VIRGINIA ELECTRIC AND POWER COMPANY
RICHMOND, VIRGINIA 23261

November 7, 2022

VIRGINIA ELECTRIC AND POWER COMPANY (DOMINION ENERGY VIRGINIA)
NORTH ANNA POWER STATION UNITS 1 AND 2
SURRY POWER STATION UNITS 1 AND 2
PROPOSED LICENSE AMENDMENT REQUEST TO
REVISE EMERGENCY PLAN STAFF AUGMENTATION TIMES

FIGURE 5.45-b

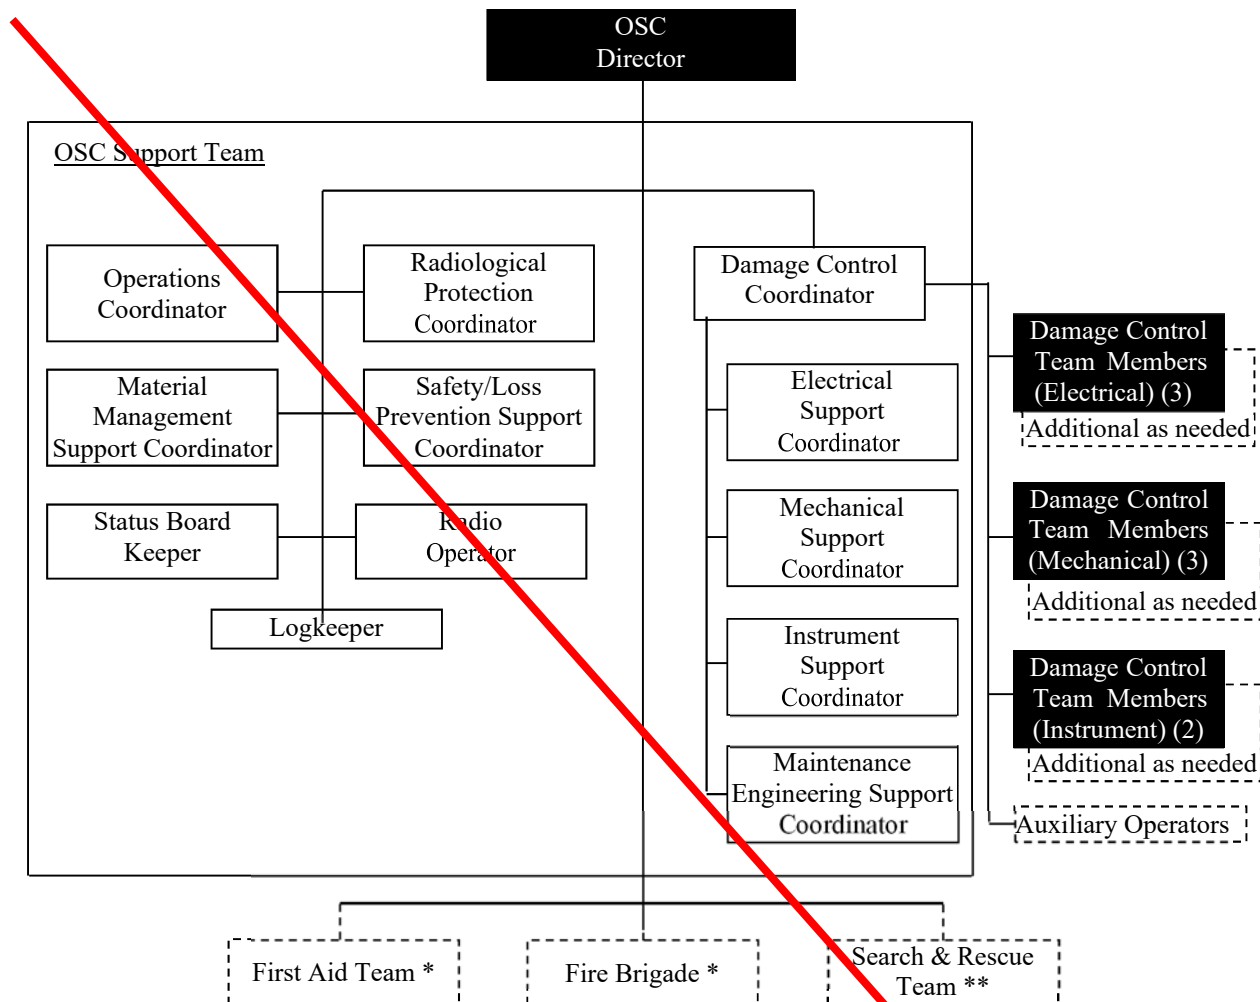
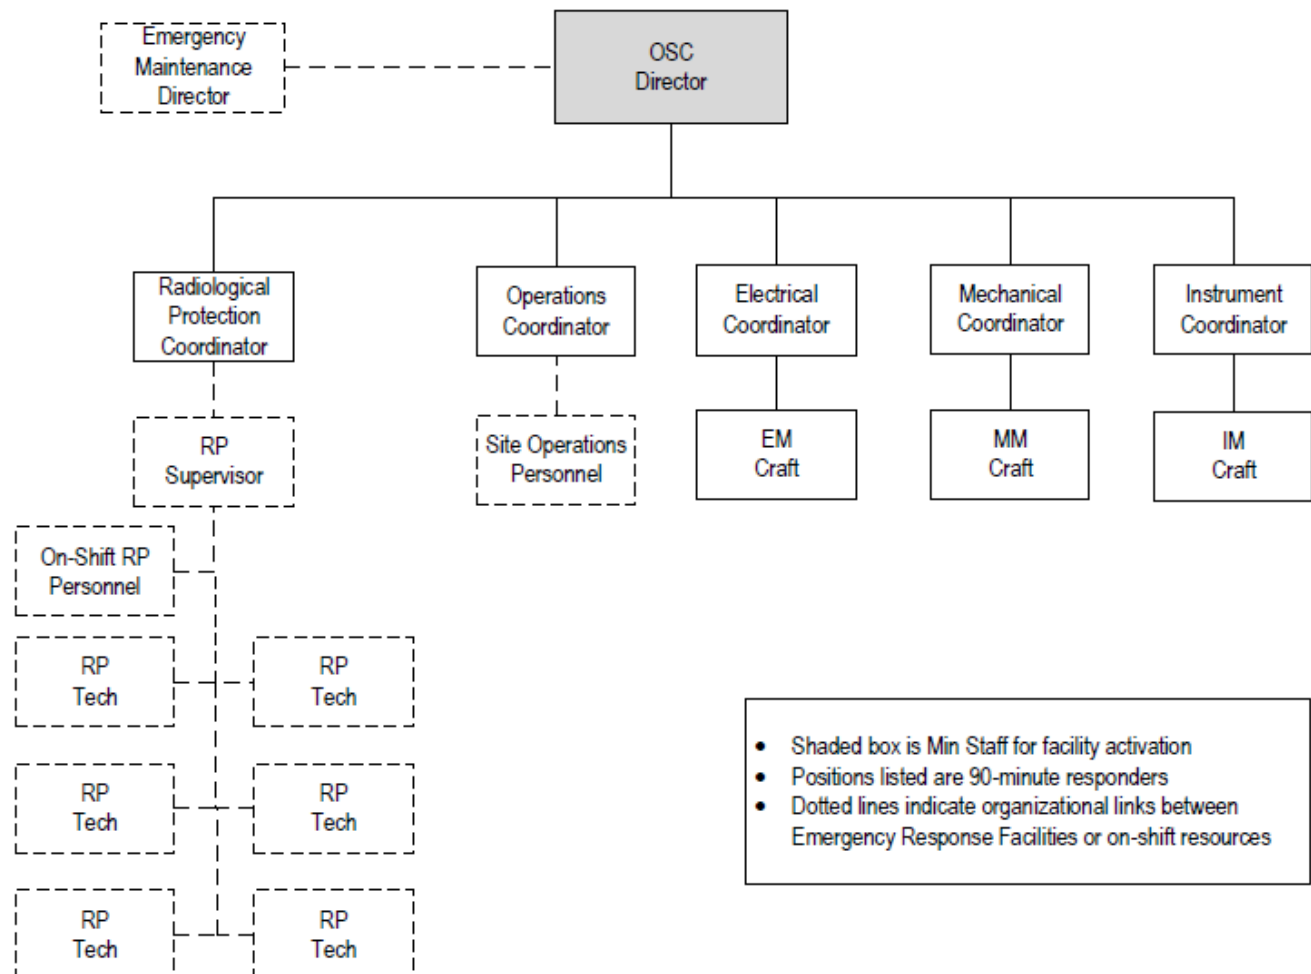
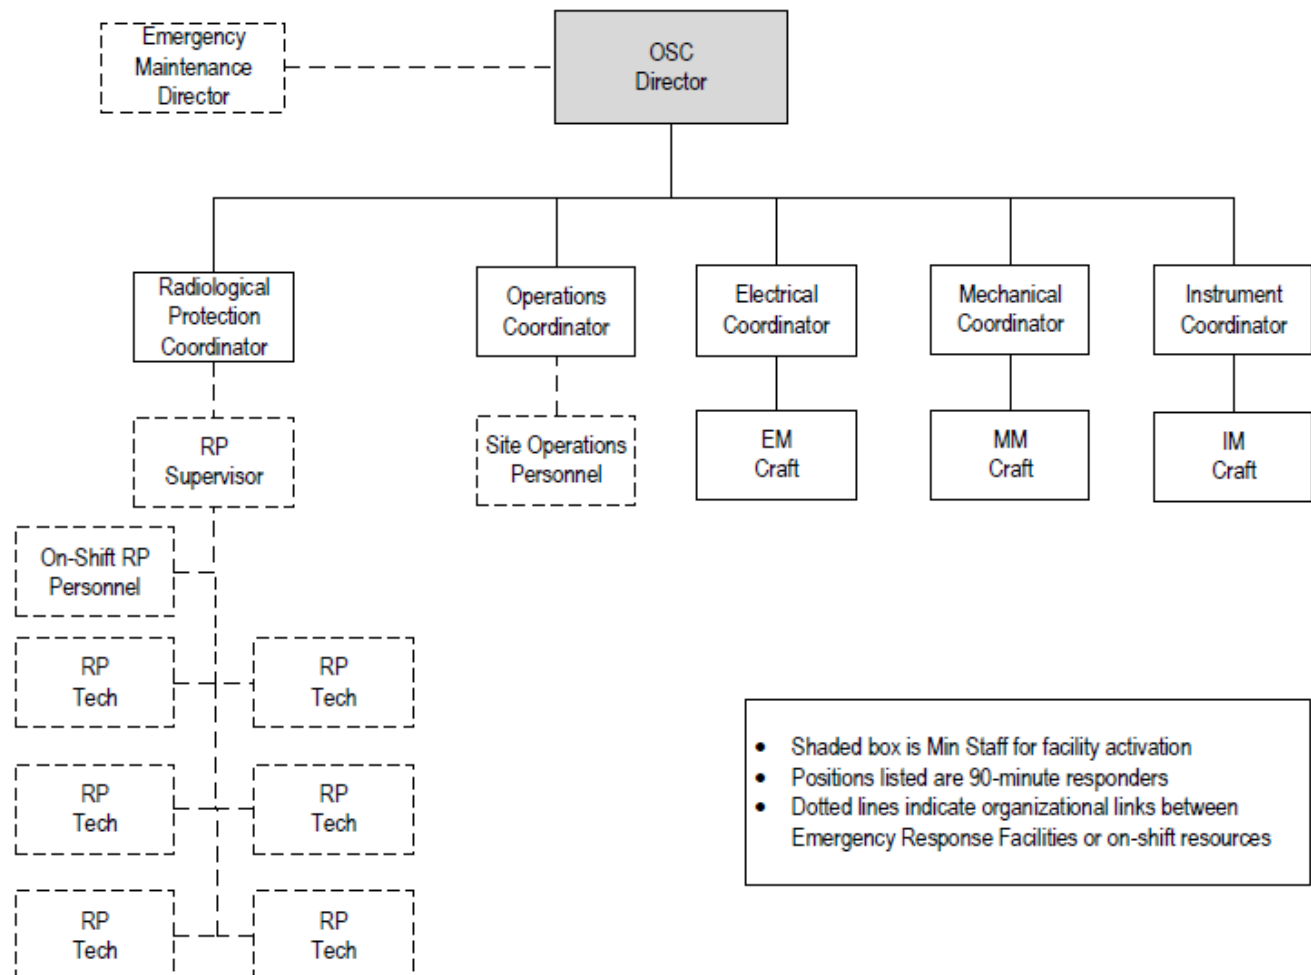
- uu. Figure 5.5.b, "Operational Support Center Organization," renumbered and revised to reflect proposed staffing and positions required for facility activation.

RADIATION PROTECTION ORGANIZATION
FIGURE 5.5.e

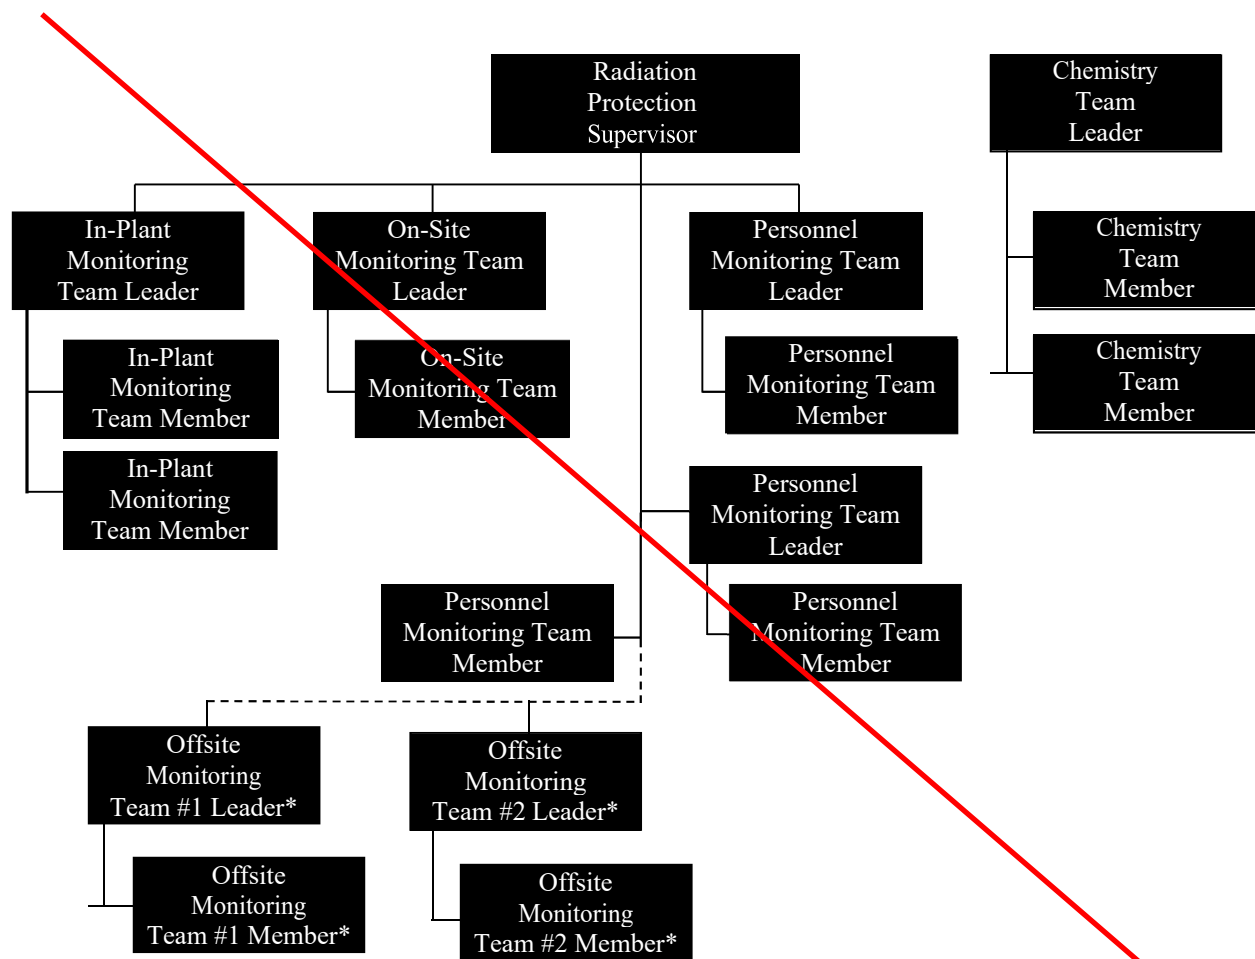
- vv. Figure 5.5.c, "Radiation Protection Organization," deleted figure. Radiological Protection (RP) responders incorporated into TSC, OSC, and CERC figures to better reflect response in each facility.

FIGURE 5.5-~~d~~

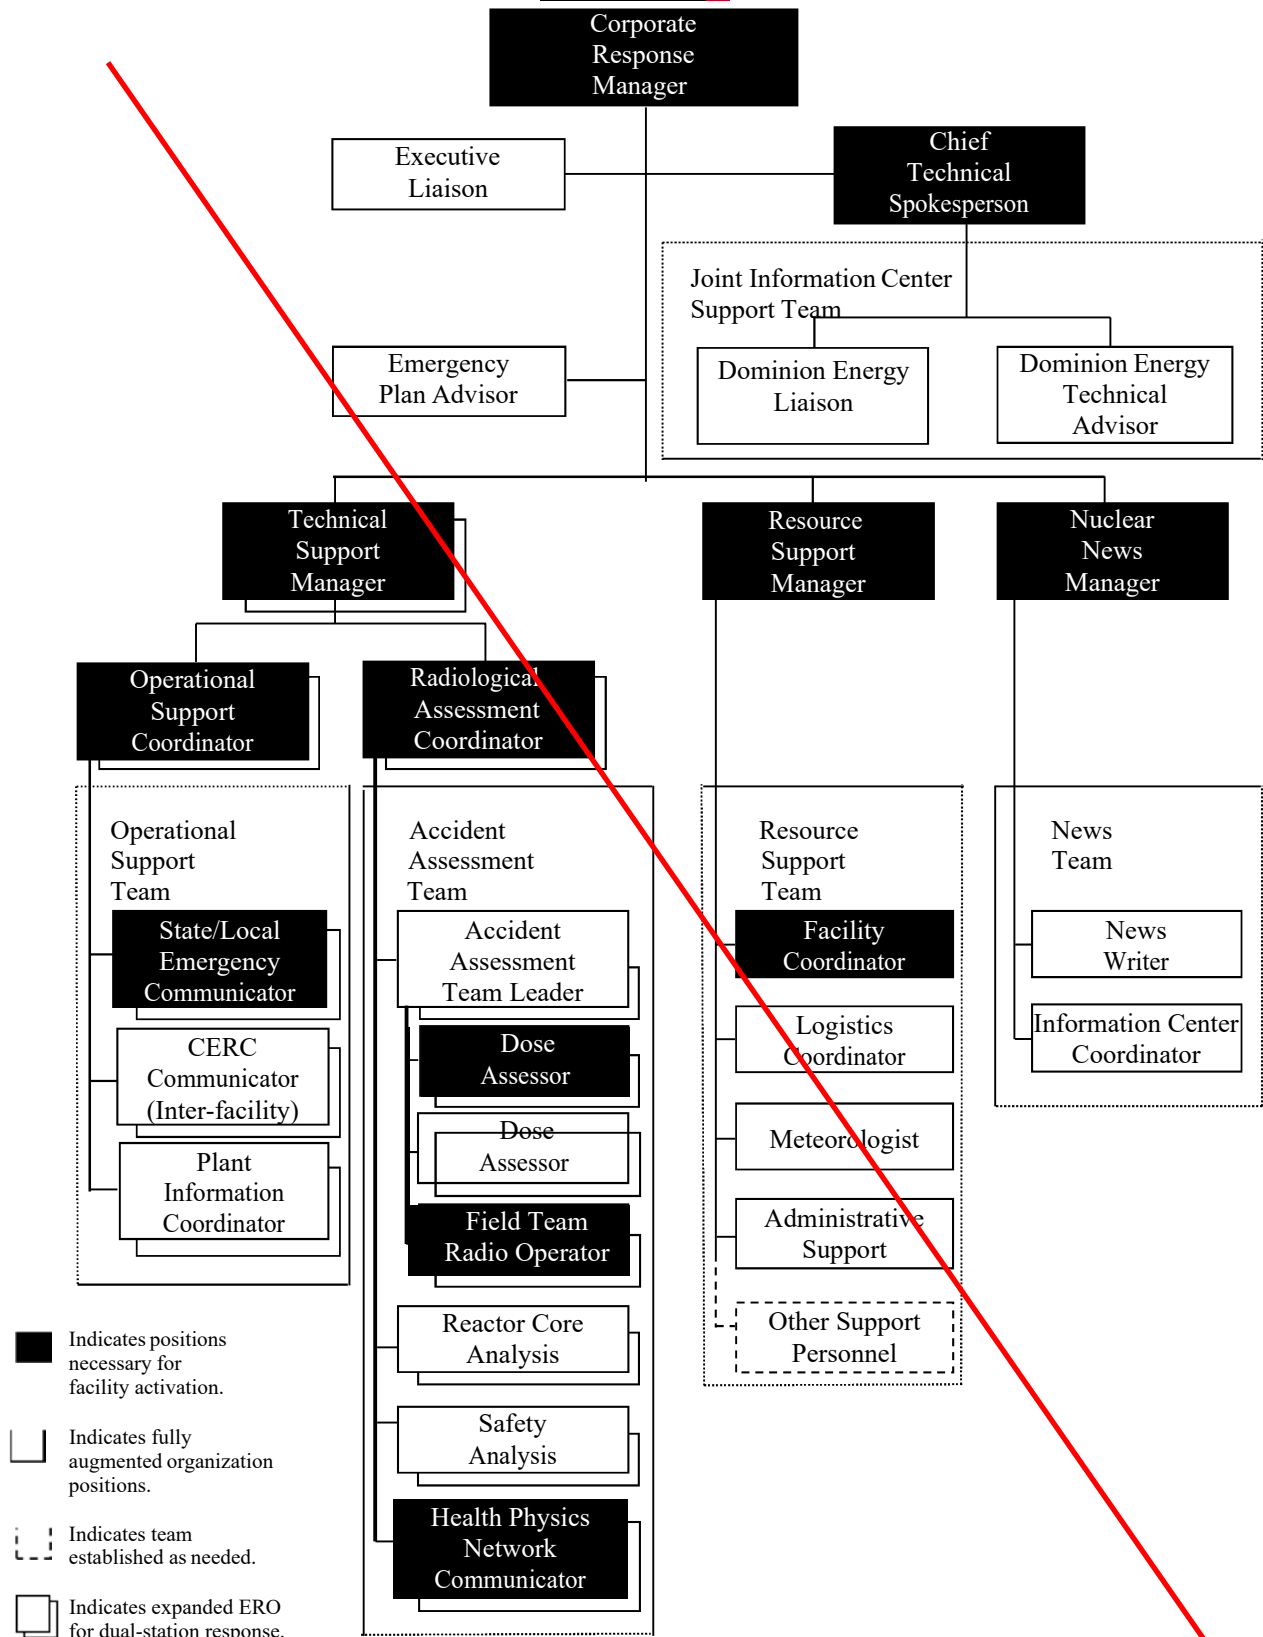
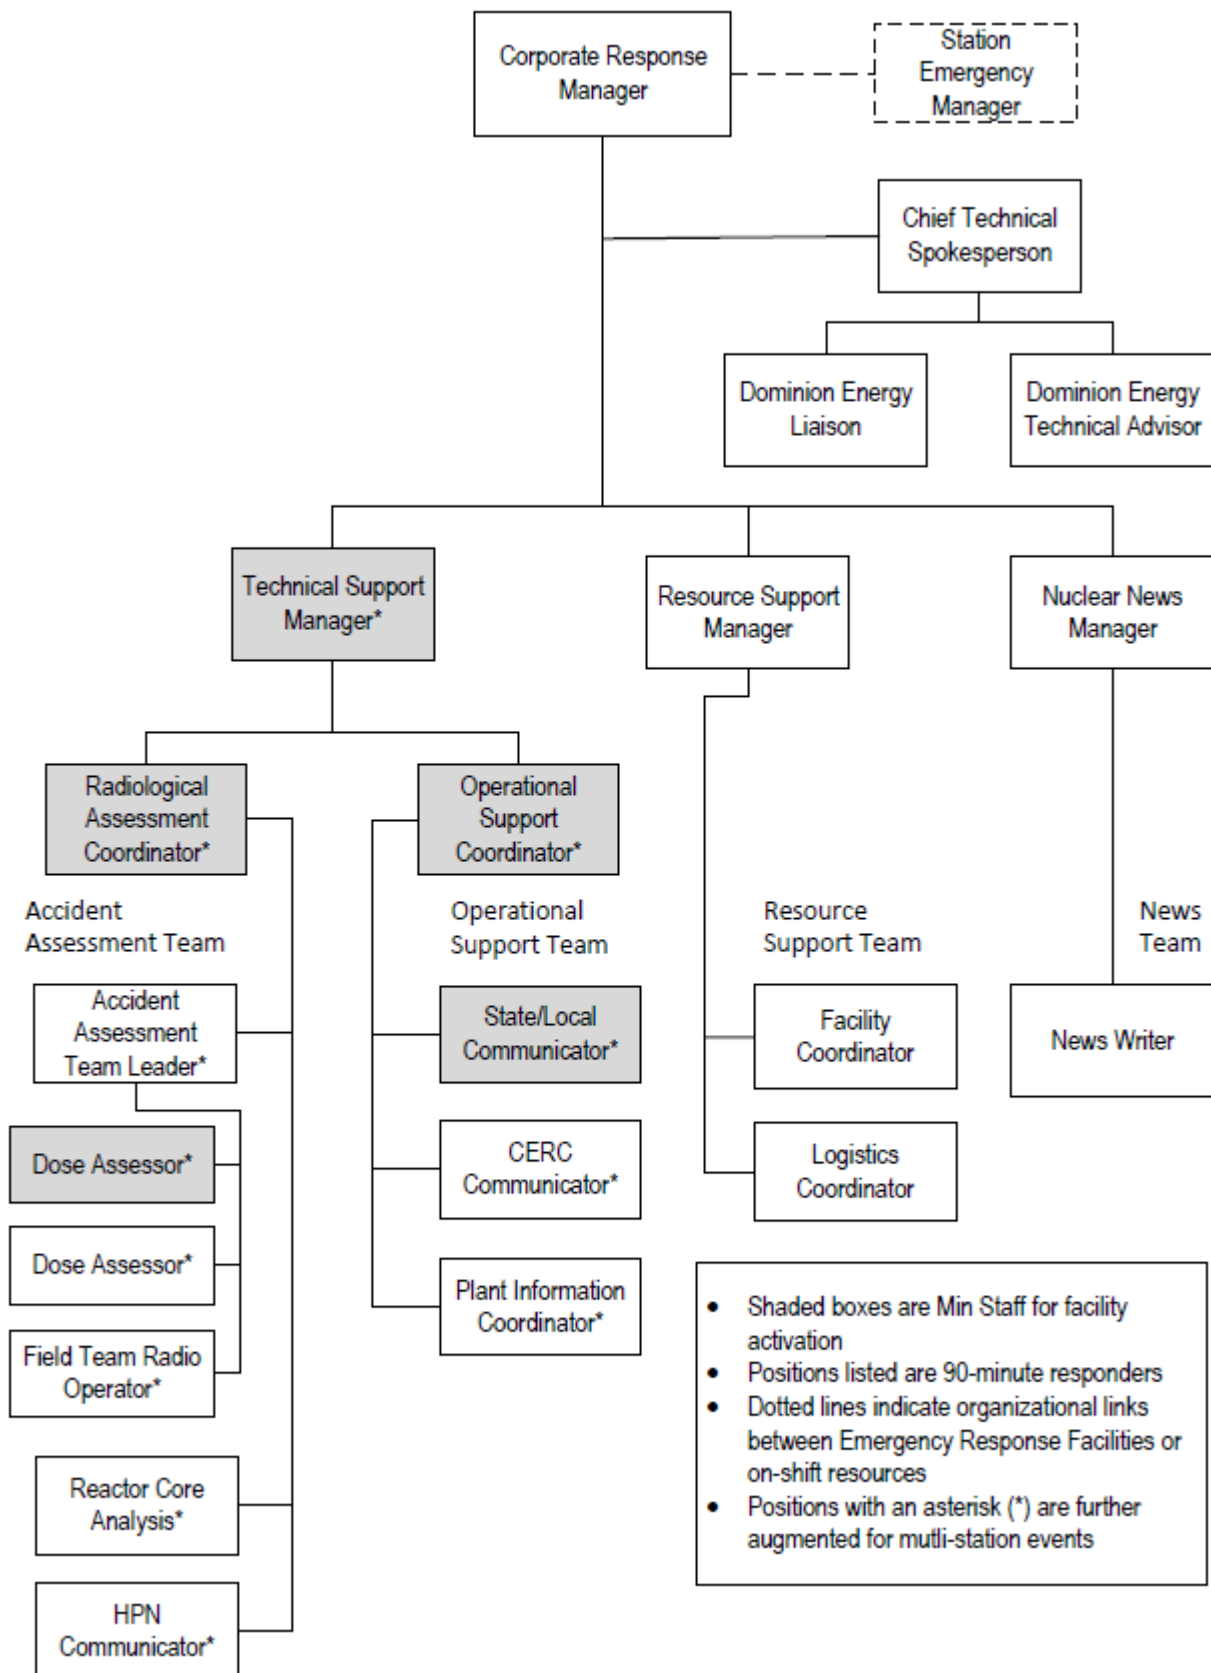
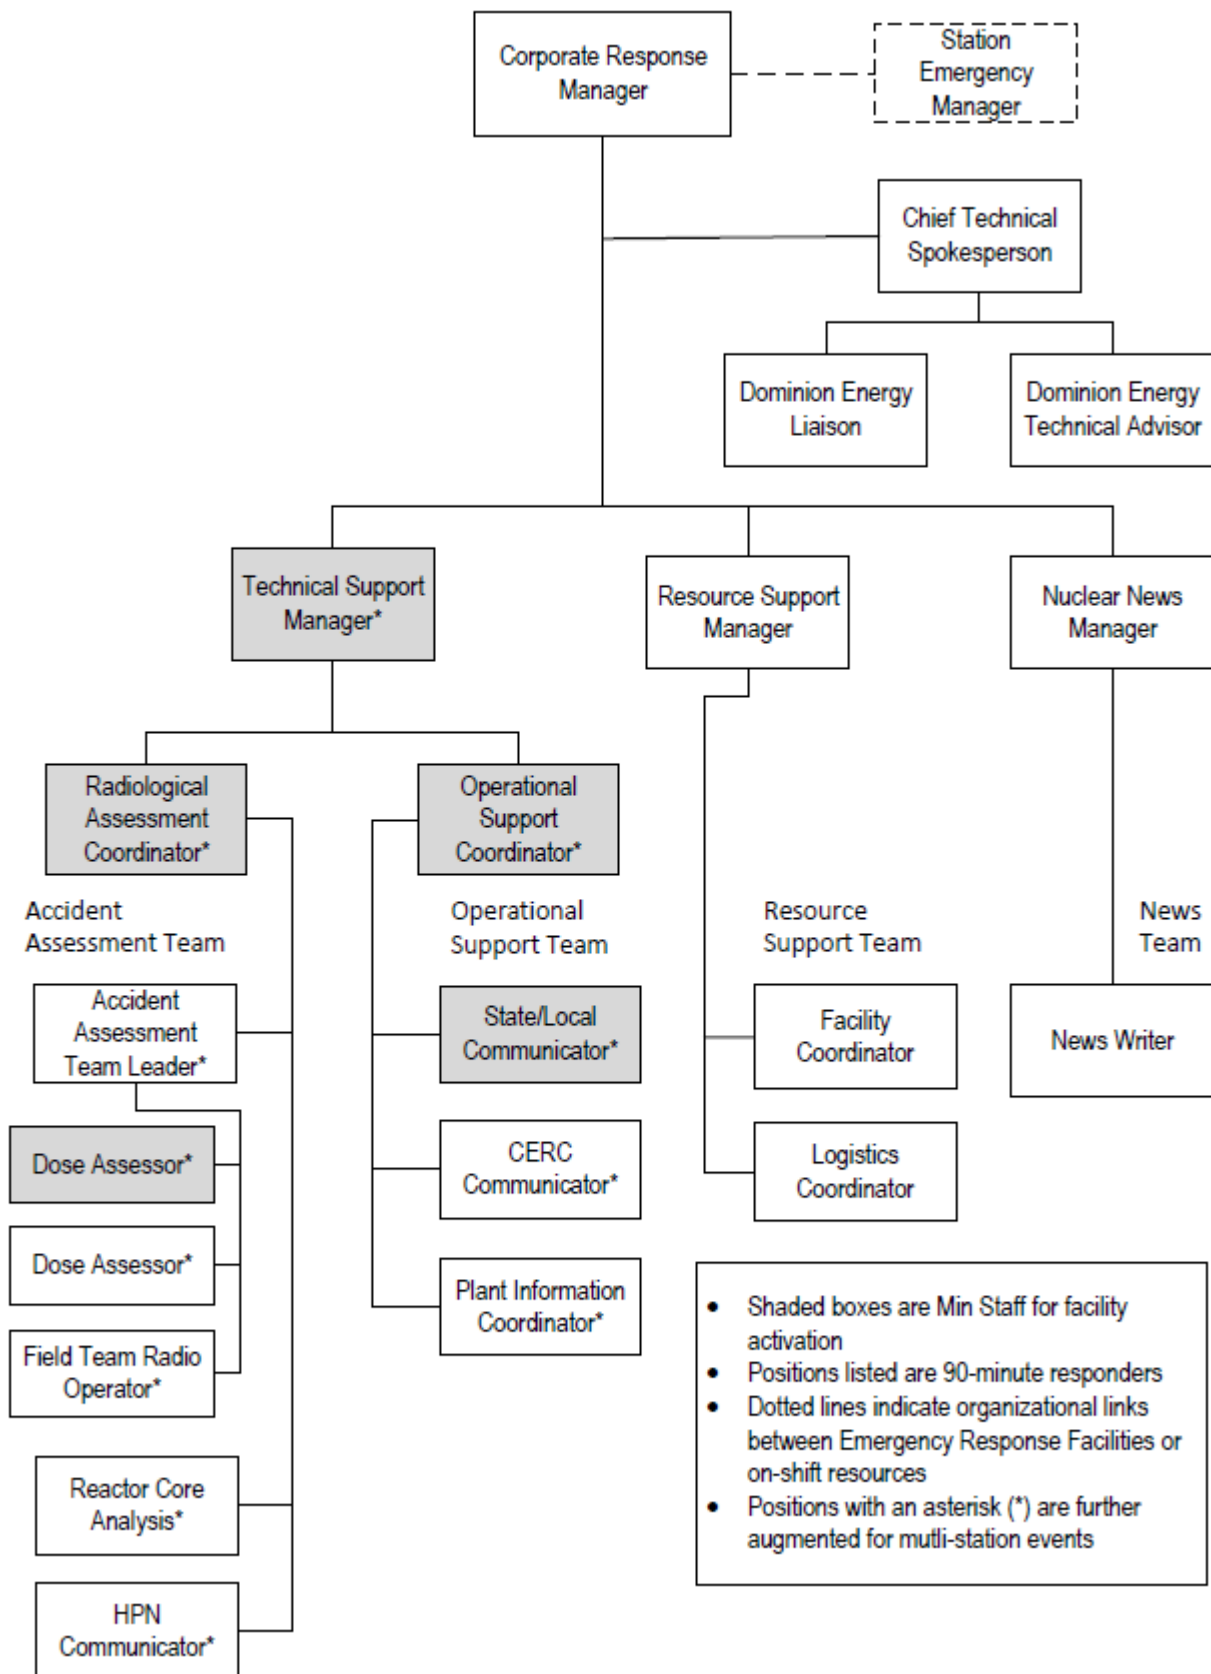
- ww. Figure 5.5.d, "Corporate Emergency Response Center Organization," renumbered section and revised to reflect proposed staffing and positions required for facility activation.
